Addendum No. 04

File Reference Number: RFQ 2026 033

Title: Supply of LED Wall Display, Installation, and Support Services

RE: Clarifications/Questions

Answer: Please find below the images for floor plans:

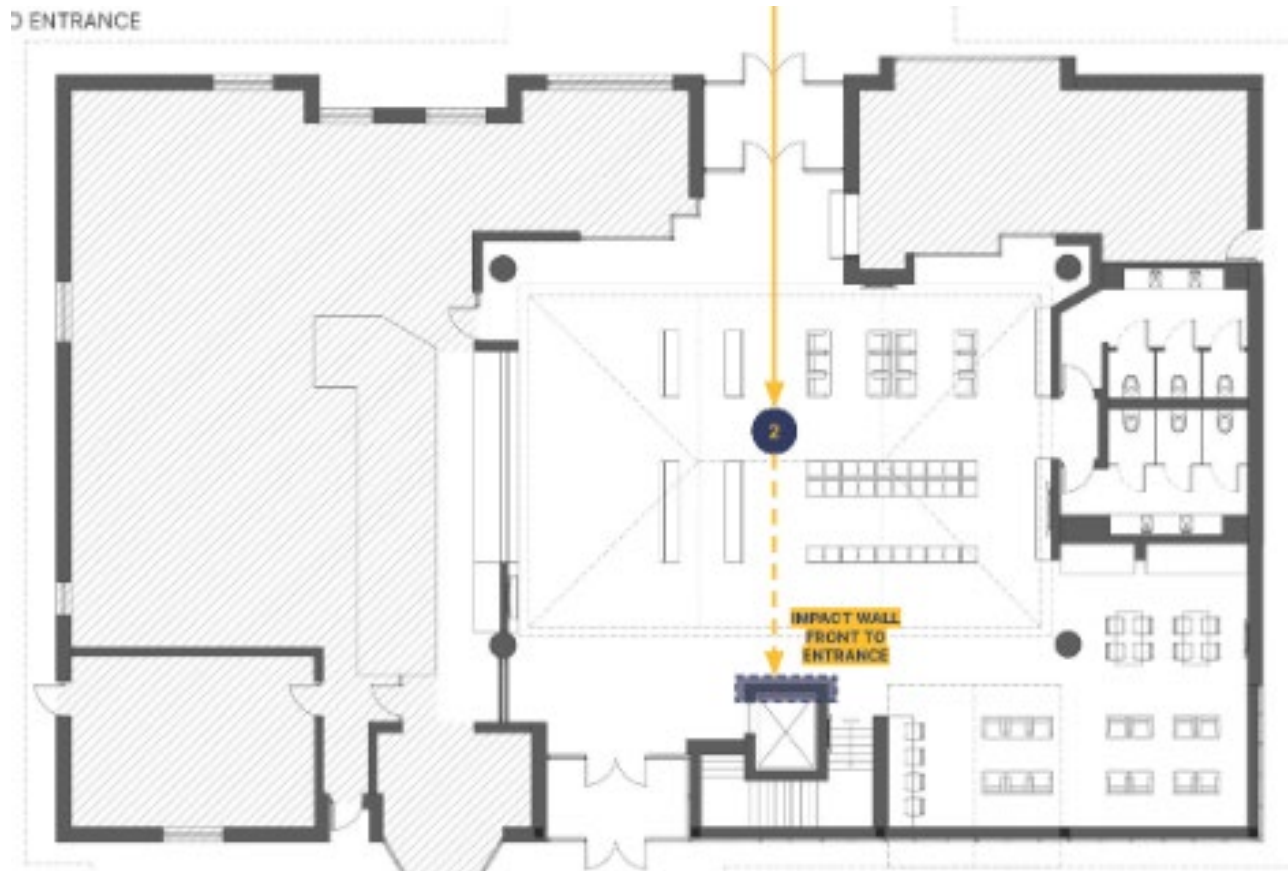
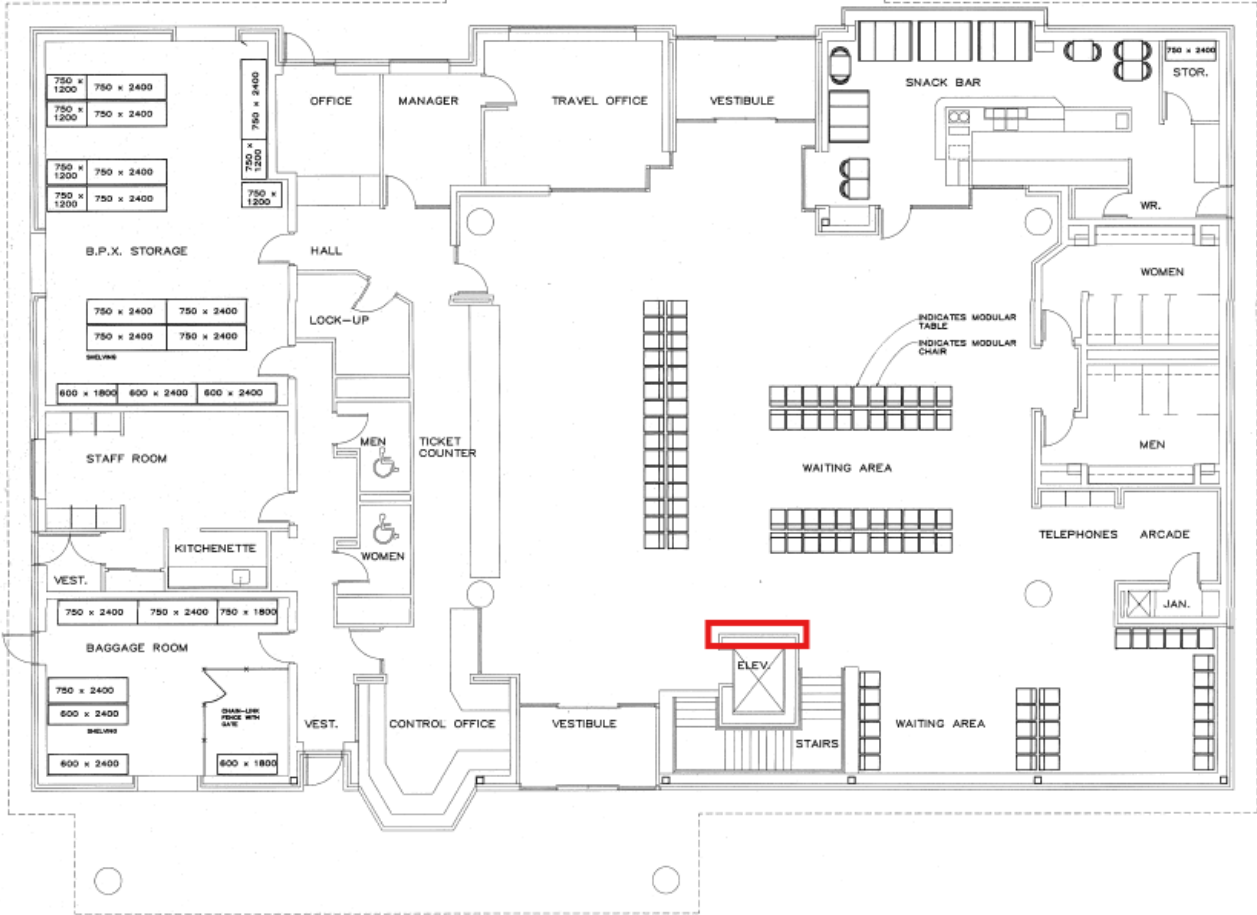
Item 1: Please provide the floor plans for the space.
